Bid Addendum 05

Project: Maritime Museum Education Center,
Beaufort, NC – Construction Phase Services

Date: August 2, 2024

SCO#: 24-27956-01A

LAYOUT AND MATERIALS PLAN ENLARGEMENT

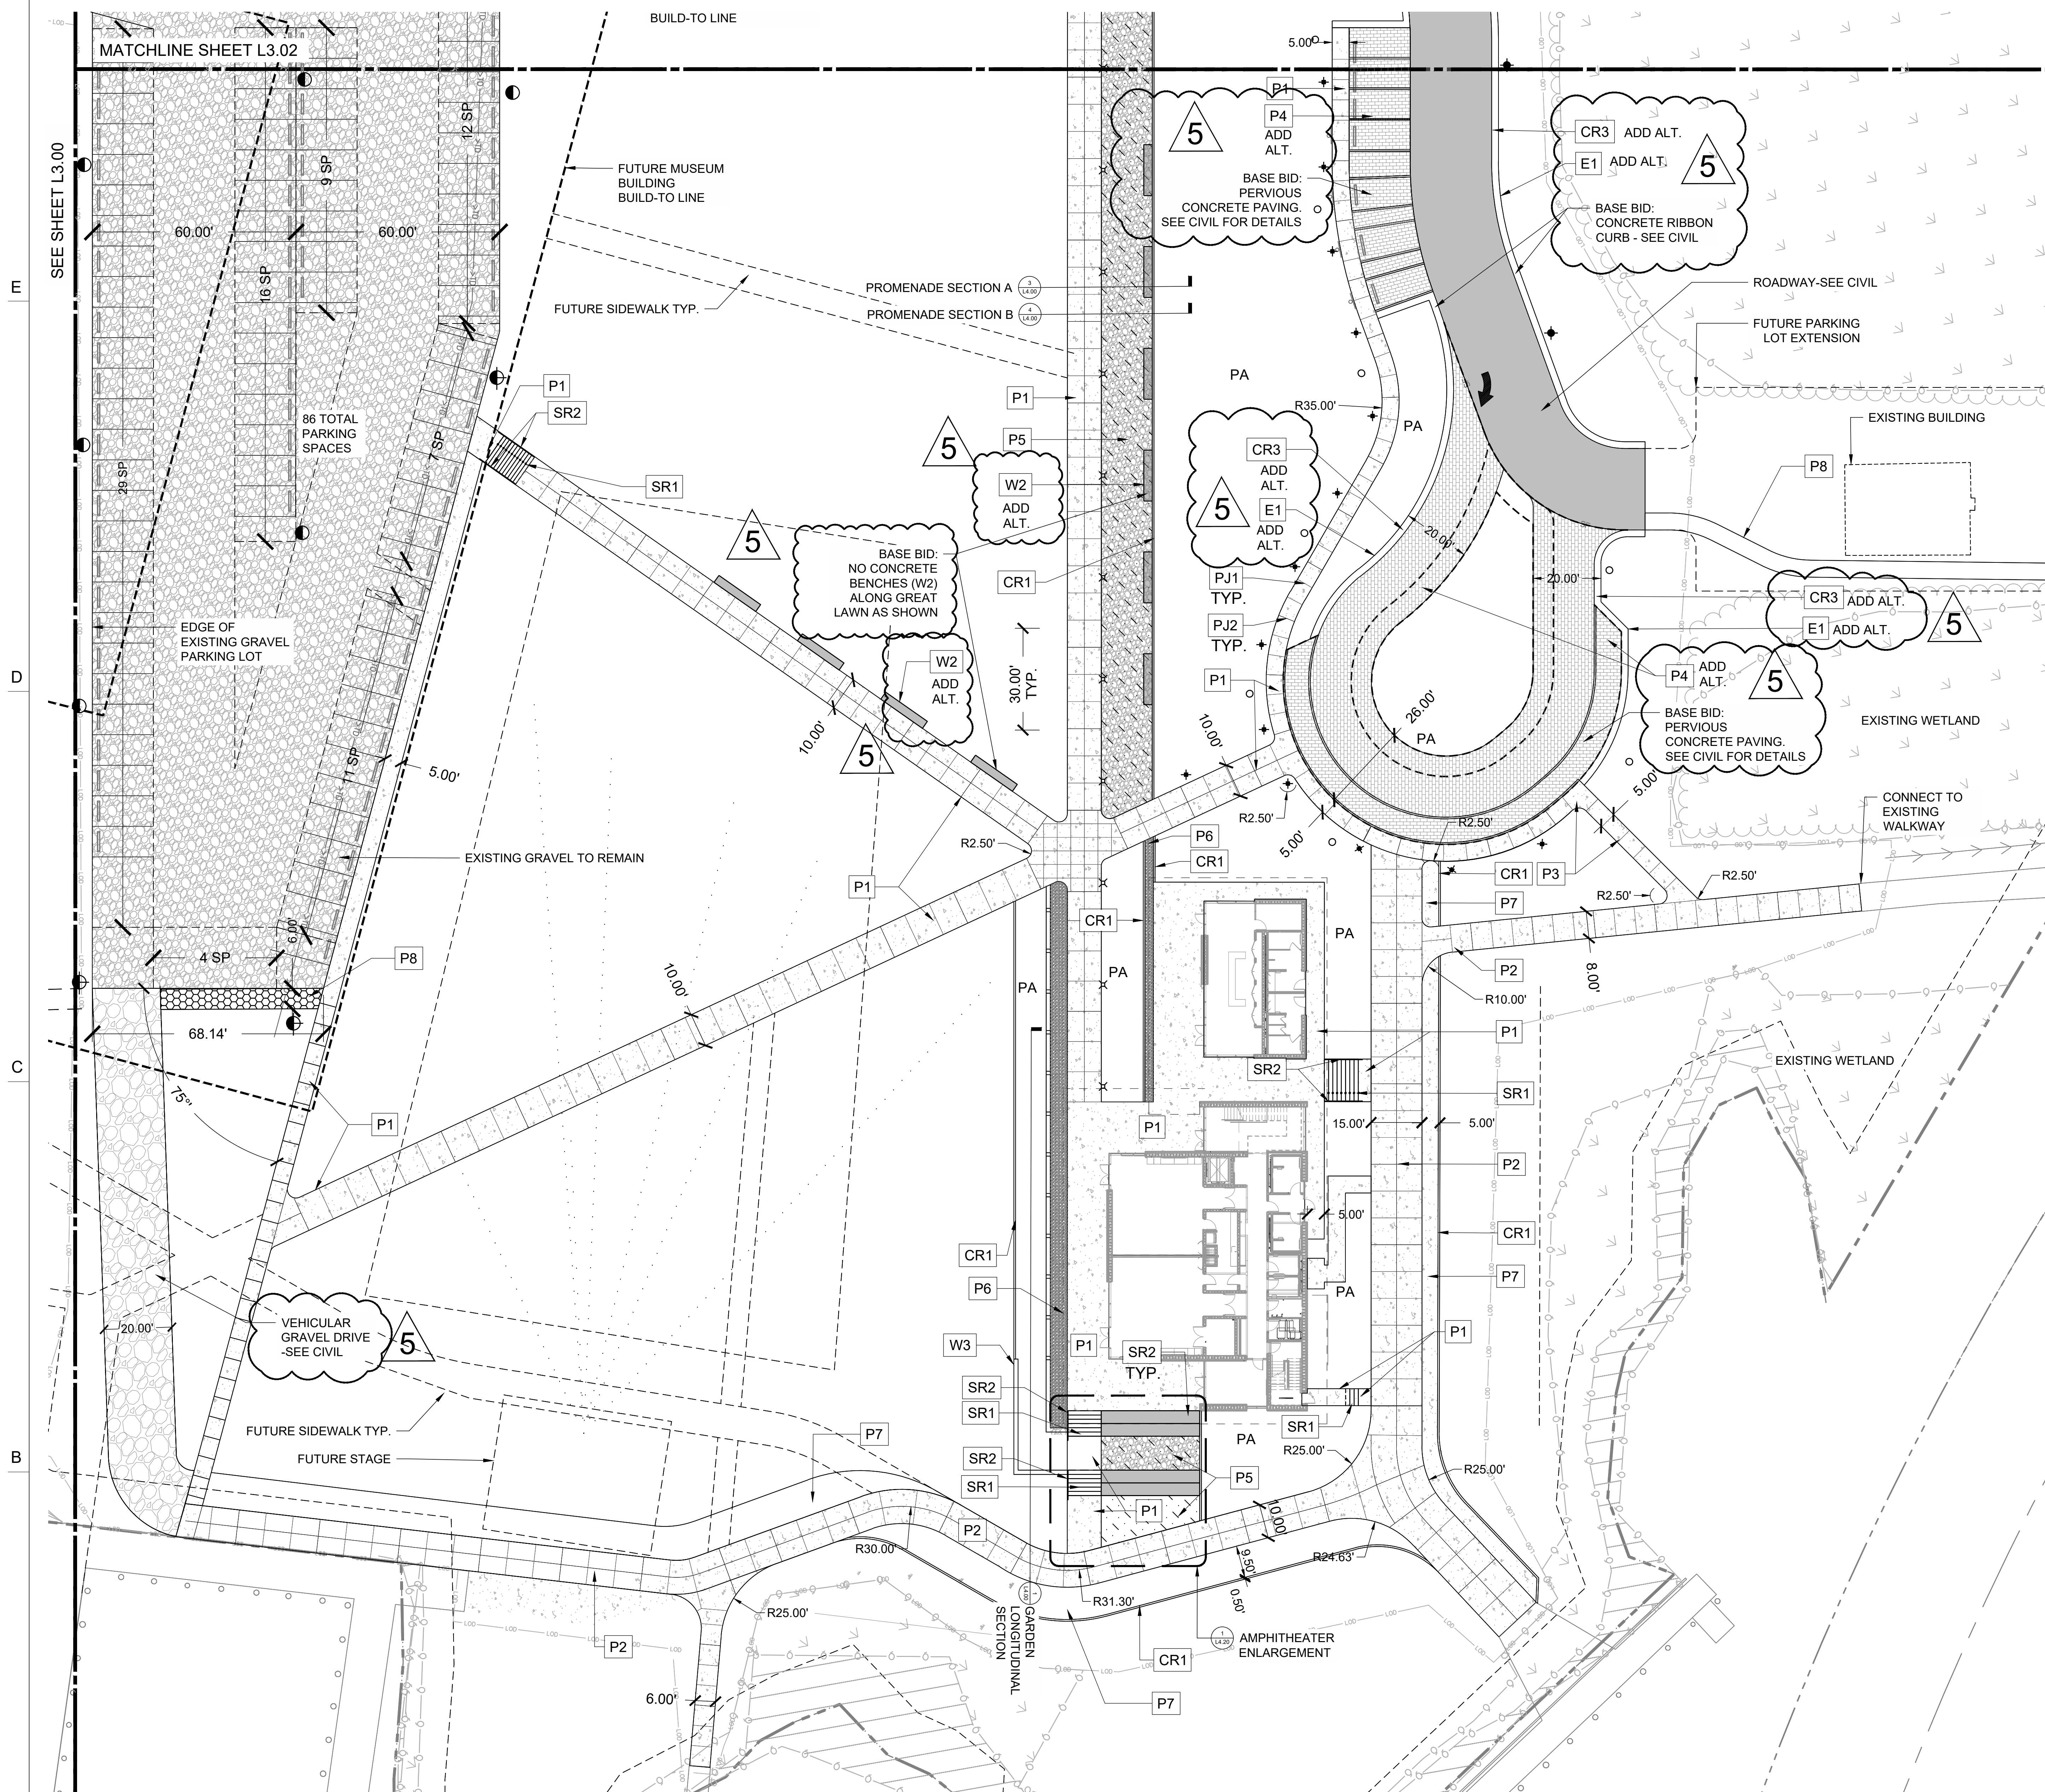
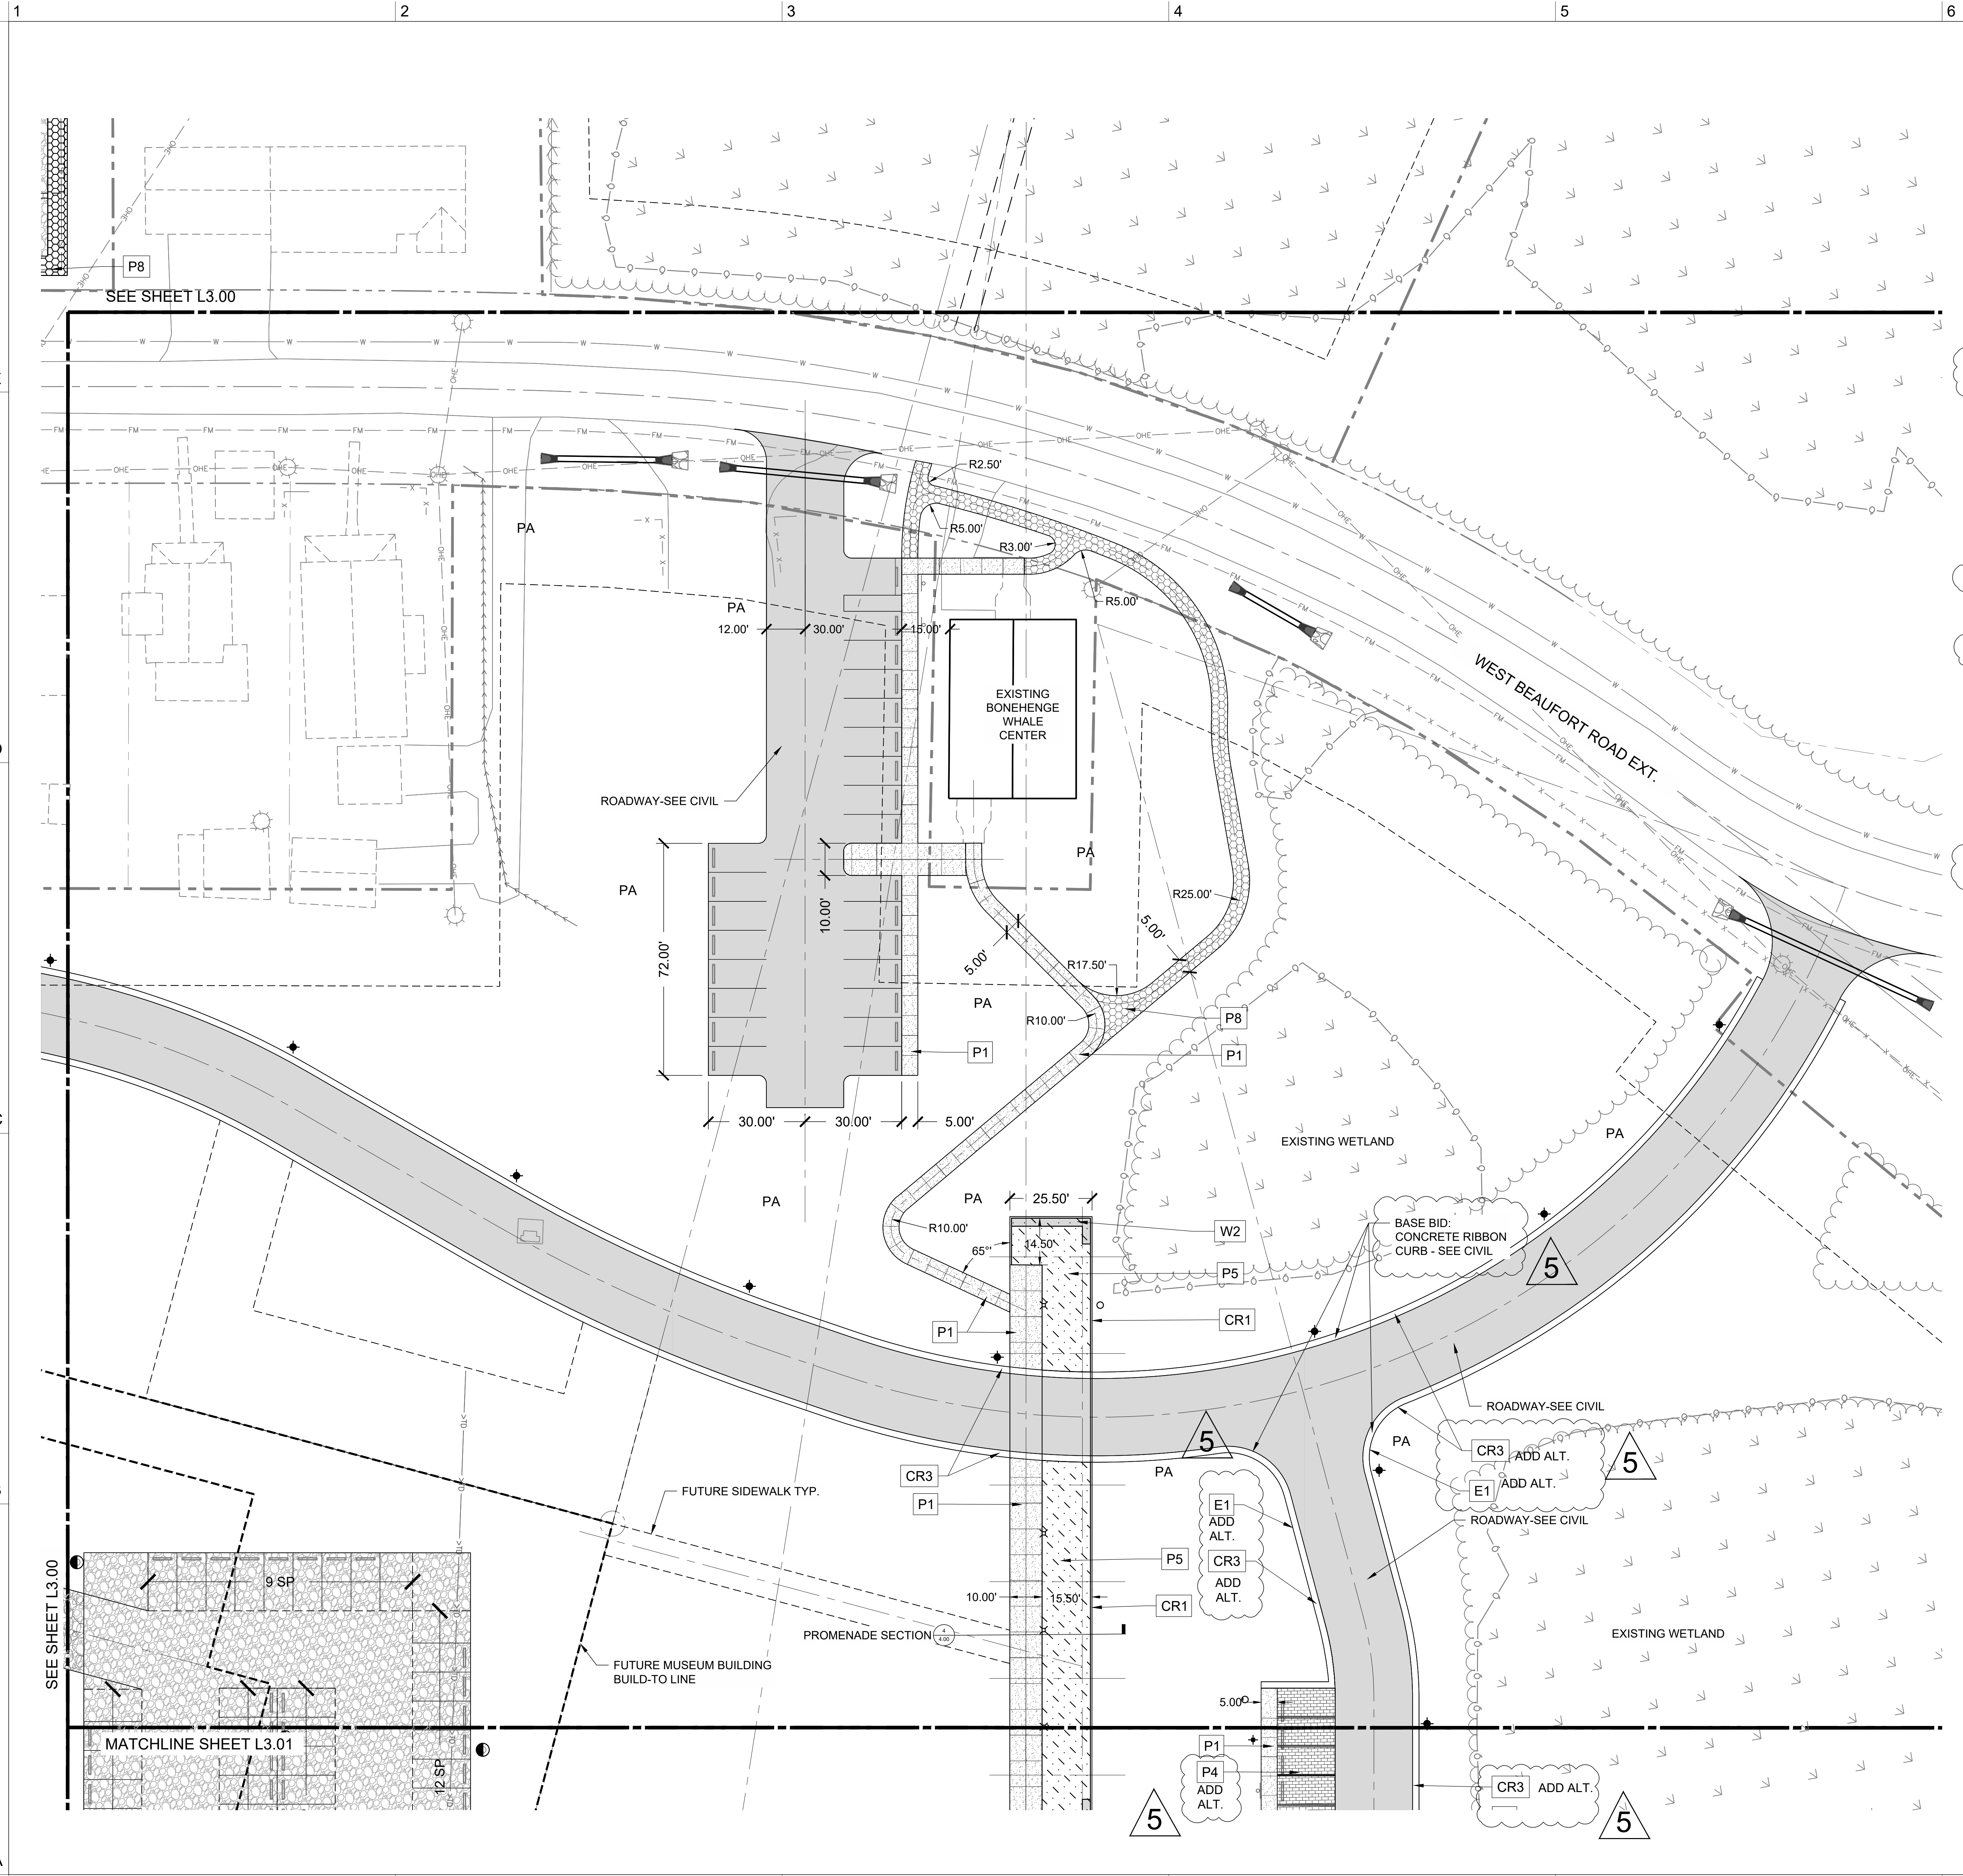
13. Sheet L3.01:
 - a. Pavement hatches have been modified.
 - b. Alternates are labeled and new tags are clouded.
14. Sheet L3.02:
 - a. Pavement hatches have been modified.

1. **QUESTION:** The large area on the west side of drawing L3.01 is noted P9. That material is neither specified on the finish schedule of the corresponding page nor the full Materials and Finish Schedule L3.03. C.200 denotes existing gravel in that area. Please clarify.

- a. **RESPONSE:** Refer to attached sheets L3.01 and C9.01. Landscape drawings have been revised to show the appropriate hatch pattern, and the Materials and Finish Schedules therein have been noted as "Gravel Drive" and updated to remove Pavement P9. An associated Gravel Pavement Detail is added on Civil sheet C9.00.
